International
Aero Engines

V2500 Propulsion System — Nacelle

NACELLE — POWERPLANT — TRANSLATING SLEEVE, THRUST REVERSER —
MODIFICATION OF — SEAL, THRUST REVERSER — REPLACEMENT OF

V2500-NAC-78-0146

Upper Translating Sleeve Disbond Examination
Figure 1

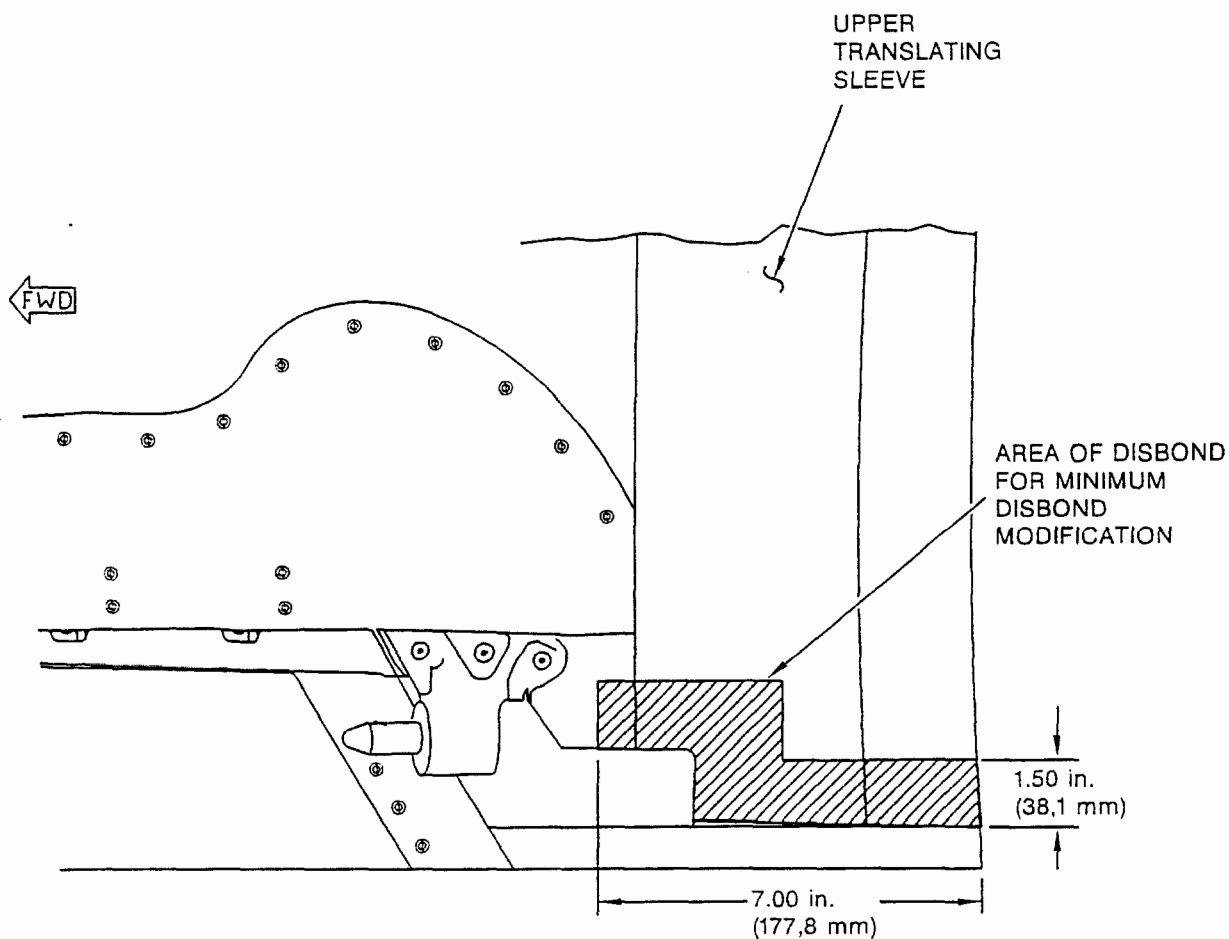
- (1) Look for separation between the core and the outer skin. Refer to Figure 1.
 - (a) If no separation is found, install the brackets and doublers as instructed in paragraph D.
 - (b) If separation is found, find out how far the separation extends.
 1. If the area of separation is equal to or less than shown in Figure 1, do the procedures instructed in paragraph E.
 2. If the area of separation is greater than shown in Figure 1 but less than or equal to that shown in Figure 2, do the procedures instructed in paragraph F.
 3. If the area of separation is greater than shown in Figure 2, contact Rohr or IAE for disposition.

Lower Translating Sleeve Disbond Examination
Figure 3

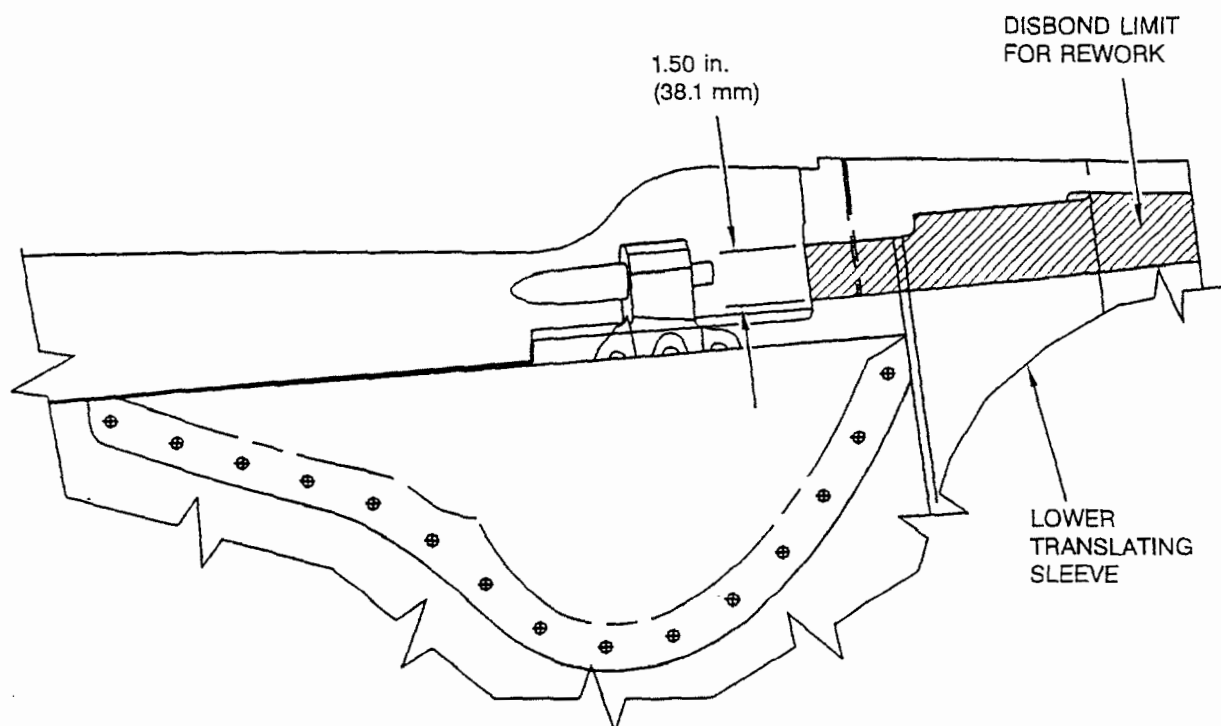
- (1) Look for separation between the core and the outer skin. Refer to Figure 3.
 - (a) If no separation is found, install the brackets and doublers as instructed in paragraph G.
 - (b) If separation is found, find out how far the separation extends.

1. If the area of separation is equal to or less than shown in Figure 3, do the procedures instructed in paragraph H.
 2. If the area of separation is greater than shown in Figure 3, contact Rohr or IAE for disposition.

Upper Translating Sleeve Modification (with minimum disbond)
Figure 4 (Sheet 1)

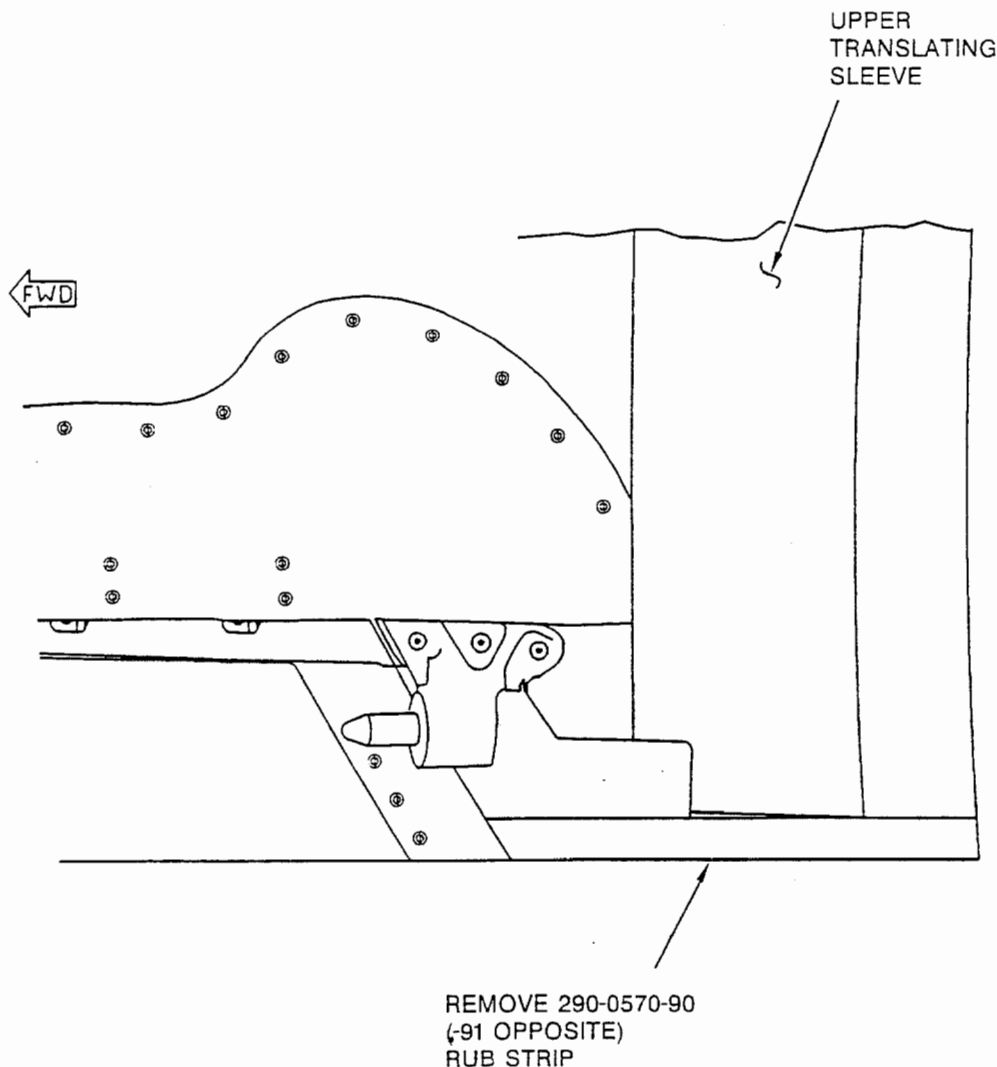
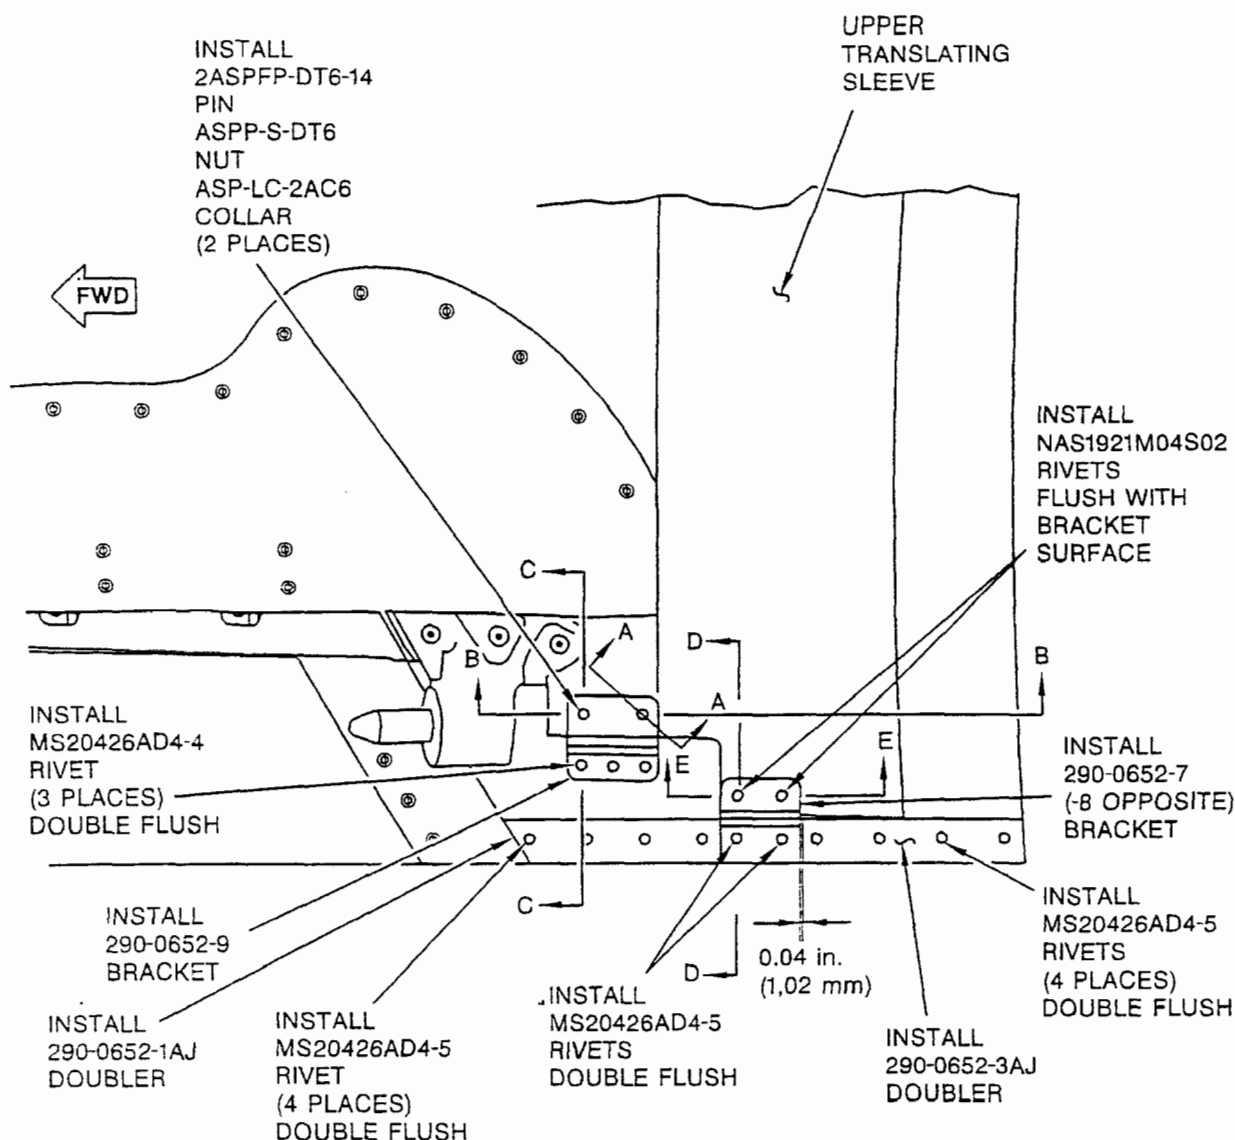
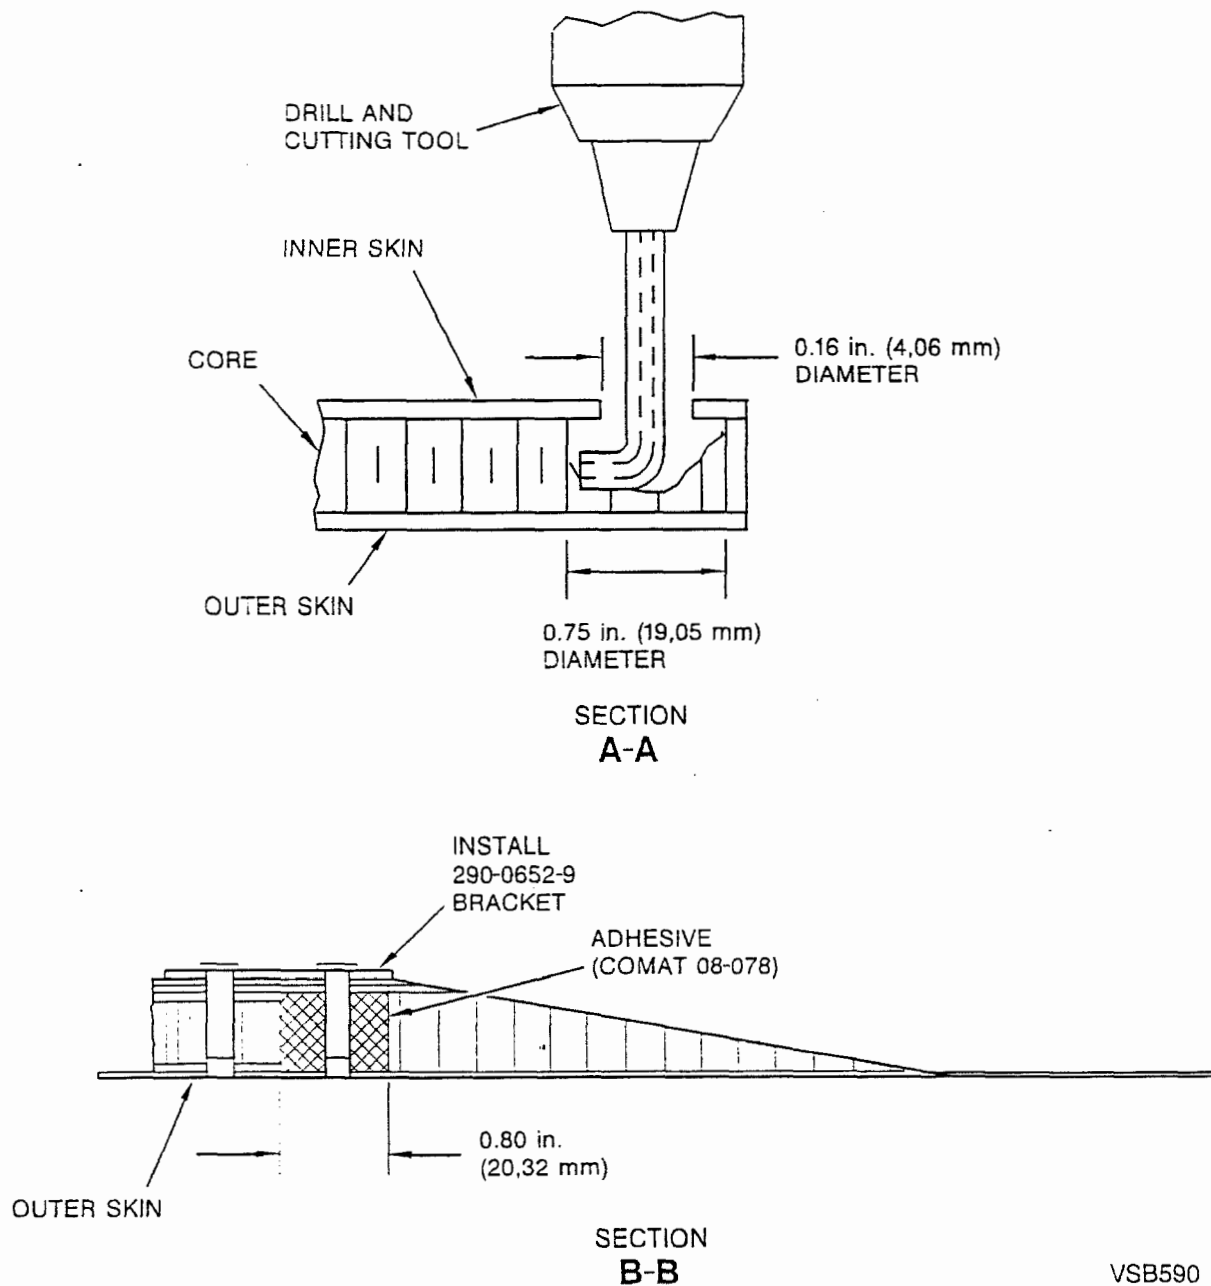
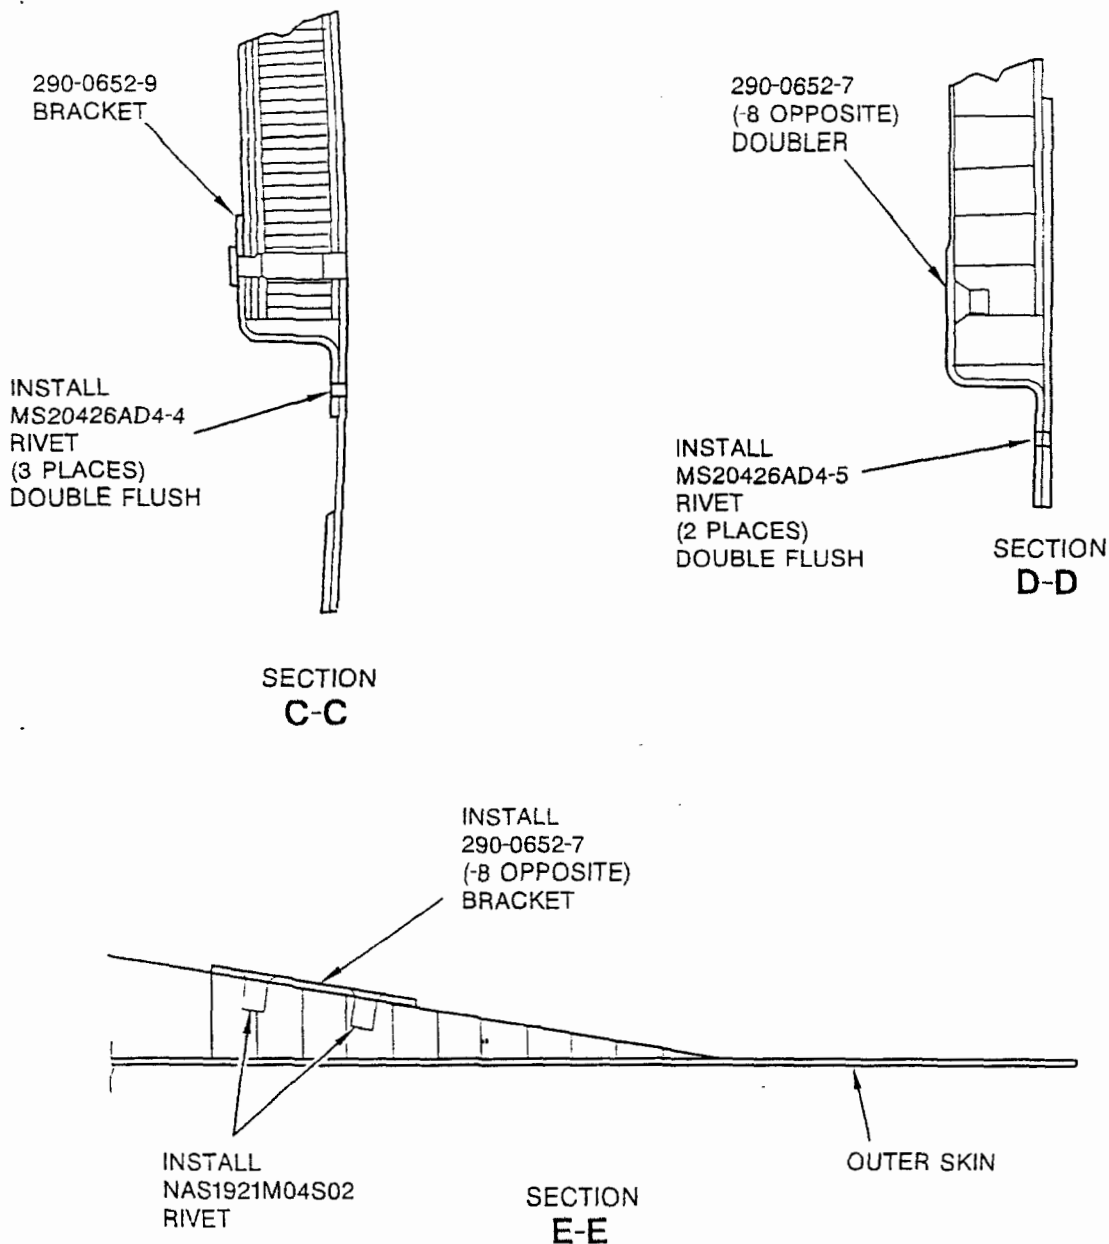
- D. Modify the Upper Translating Sleeve (no disbond)(kit V2578146-551 - LH nacelle)(kit V2578146-552 - RH nacelle)
- (1) Remove the bonded rub strip 290-0570-90 (290-0570-91). Refer to Figure 4 (sheet 1). Discard the rub strip.

- (2) Prepare one fastener hole for the 290-0652-9 bracket. Refer to Figure 4 (view A-A).
 - (a) Put the 290-0652-9 bracket into position on the translating sleeve and make a mark for the aft upper fastener hole.

- (b) At the position marked in step (a), drill a 0.16 inch (4.06 mm) hole through the inner skin and the core. Do not drill through the outer skin.
 - (c) Remove the core to a diameter of 0.75 inch (19.05 mm) through the hole drilled in step (a).

- E. Modify the Upper Translating Sleeve (with minimum disbond)(kit V2578146-551 - LH nacelle)(kit V2578146-552 - RH nacelle))
- (1) Remove the bonded rub strip 290-0570-90 (290-0570-91). Refer to Figure 4 (sheet 1). Discard the rub strip.

- (2) Prepare one fastener hole for the 290-0652-9 bracket. Refer to Figure 4 (view A-A).
 - (a) Put the 290-0652-9 bracket into position and make a mark for the aft upper fastener hole.

- (b) At the position marked in step (a), drill a 0.16 inch (4.06 mm) hole through the inner skin and the core. Do not drill through the outer skin.
 - (c) Remove the core to a diameter of 0.75 inch (19.05 mm)

- (8) Install the brackets and doublers with the fasteners. Wet install the fasteners with adhesive (CoMat 08-078). Refer to Figure 4.
- (9) Cure the adhesive under mechanical pressure for 2 hours at room temperature then for 2 hours at 200 ± 10 degrees F.
- (10) Trim brackets and doublers to agree with the shape of the acoustic panels.
- (11) Clean the bare metal surfaces with a lint free cloth (CoMat 02-099) made moist with solvent (CoMat 01-438). Wipe the surfaces dry before the solvent becomes dry.

- (7) Apply a 0.010 inch (0.25 mm) thick layer of adhesive (CoMat 08-078) to the mating surfaces of the brackets and doublers.
- (8) Install the brackets and doublers with the fasteners. Wet install the fasteners with adhesive (CoMat 08-078). Refer to Figure 4.
